MEMORANDUM

TO: District of Columbia Board of Zoning Adjustment

DATE: June 9, 2015

SUBJECT: BZA #19011 – 129 Varnum Street, NW

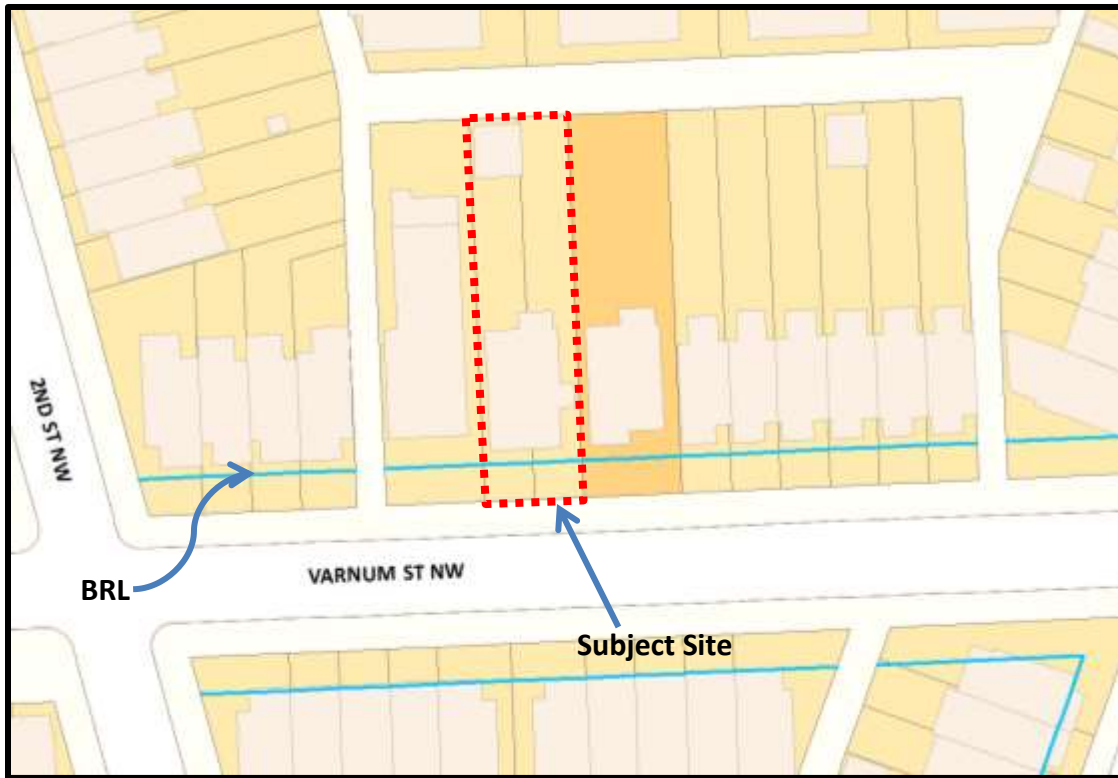
The applicant proposes a seven-unit multi-family building which would abut the front building restriction line (BRL). The BRL is located approximately five feet in front of the existing front porch, and it appears that all homes along this block were set back from the BRL the same distance. A new building built out to the BRL would not be visually compatible with the remainder of the block, and the proposed building should be set back to be in line with the other homes. See the map below showing the BRL and existing building footprints.
